**Response to Public Comment on the Draft
2018 Section 303(d) List of Impaired Waters
and the Draft Consolidated Assessment and Listing
Methodology**

August 8, 2019

**STATE OF NEW HAMPSHIRE
DEPARTMENT OF ENVIRONMENTAL SERVICES
29 HAZEN DRIVE
CONCORD, N.H. 03302**

Figure 1: Bellamy River – Light Attenuation Data (2018 GBE TSD at 69)

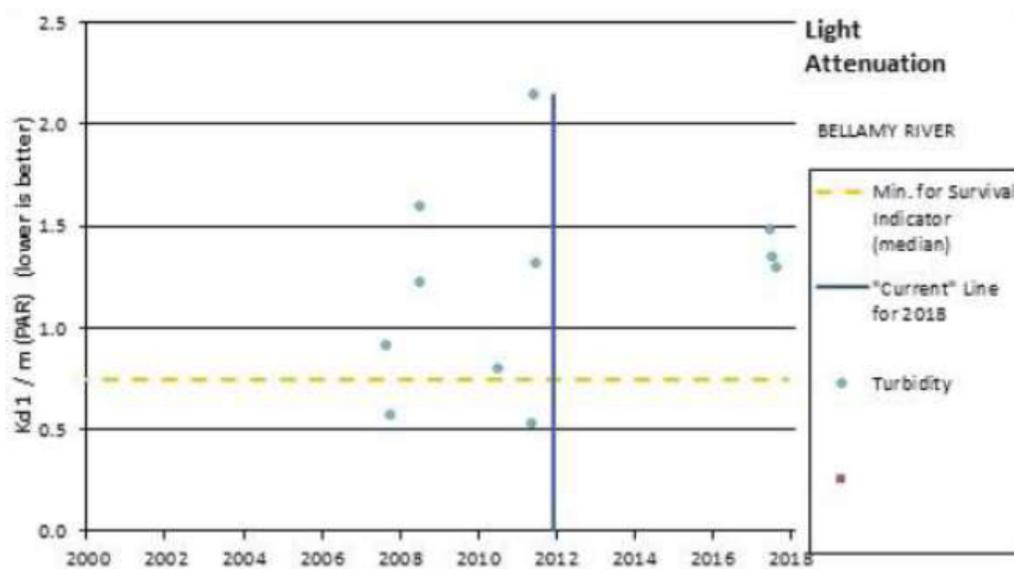
The Bellamy River was inappropriately listed as impaired for light attenuation based on three current (since 2012) data (Figure 1):

The K_d data used to assess the Bellamy River as impaired for water clarity neither meet the data requirement for minimum sample size of current K_d data nor the requirement for representative data covering all four seasons. As such, the Bellamy River 303(d) listing should be revised to 3-PNS until sufficient data have been collected and evaluated.

Figure 1. Continuous recorder dissolved oxygen data (station GRBCR) from 2016 (top) and 2017 (bottom) used in the 2018 303(d) assessment of the tidal Cocheco River ([segment NHEST600030608-01](#)).

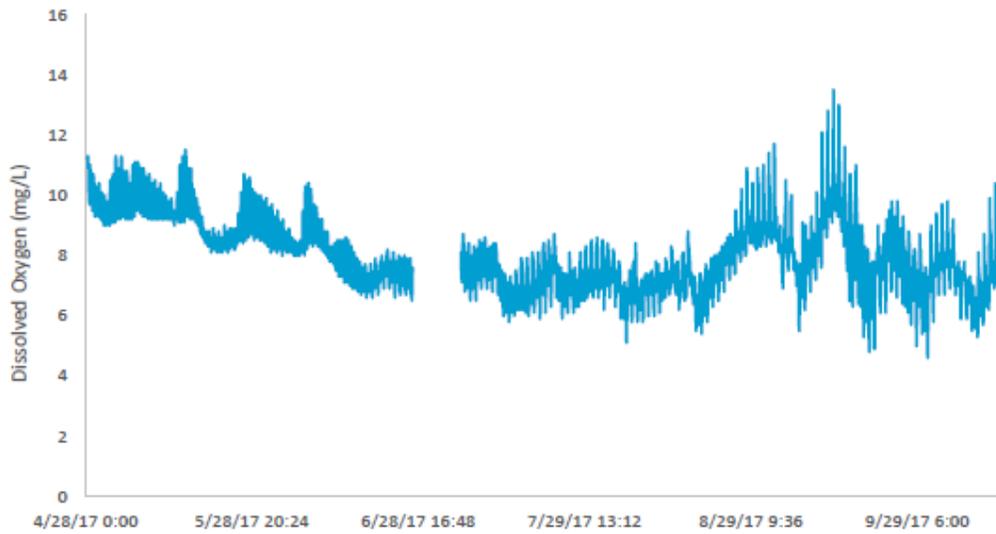
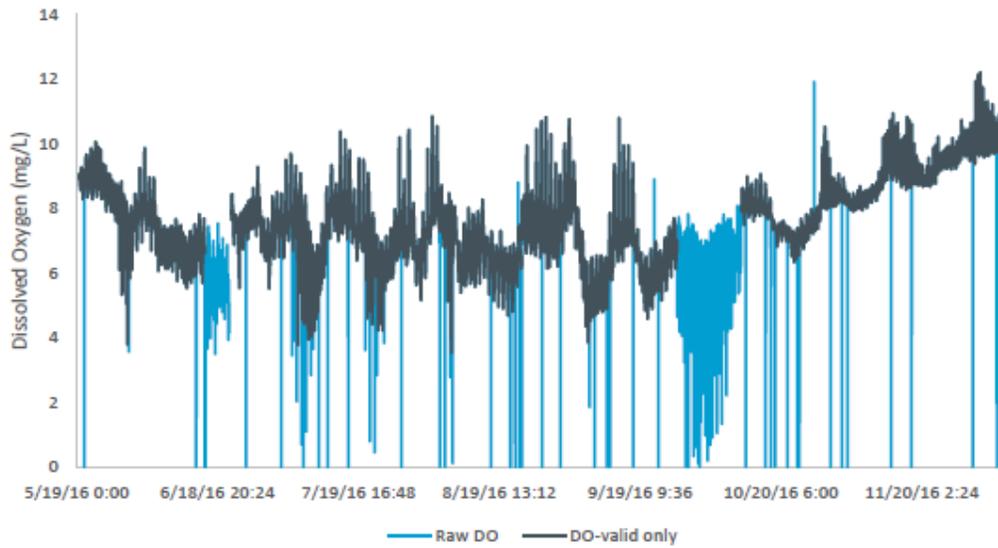
The 2016 deployment dataset exhibited several periods of questionable data, leading to a sizable amount of data that was qualified and removed from the assessment. Over 10 percent of the total deployment dataset was qualified for numerous reasons: erroneous “0 mg/L” measurements; time periods removed for biofouling; and other small but frequent periods of time (two-hour time segments) that appear to represent unexplained large magnitude changes in DO over a short time period (Figure 1). A data quality error rate of more than 10 percent is typically too high to consider the dataset valid, especially for regulatory purposes.

Further evidence of the data quality issues in the tidal Cocheco River dataset can be found in a comparison of the 2016 and 2017 deployment data. While numerous time periods of questionable data are evident in the 2016 dataset, none are found in the 2017 dataset (Figure 1). No data records were removed by NHDES from the 2017 dataset for erroneous measurements, biofouling, or large magnitude DO sag/rebound cycles. The 2017 dataset exhibits characteristic DO diel, tidal cycle, and seasonal fluctuations, without the anomalous or erroneous data that are exhibited in the 2016 dataset. The reasons for this are not entirely understood at this time, but may reflect several differences including a different data sonde, a new or different DO probe, a new sonde deployment location, or any combination of these. Whatever the reason, an obvious improvement in data quality is observed in the 2017 dataset allowing for a more reliable assessment of the tidal Cocheco River.

Based on the discussion above, NHDES should revise the 2018 listing for the tidal Cocheco River to category 3-PAS as an interim listing until such time as more high quality data can be collected and assessed. Given the data quality issues in continuous recorder data prior to 2017, these data cannot be relied upon to make accurate regulatory decisions regarding water quality conditions in the tidal Cocheco River.
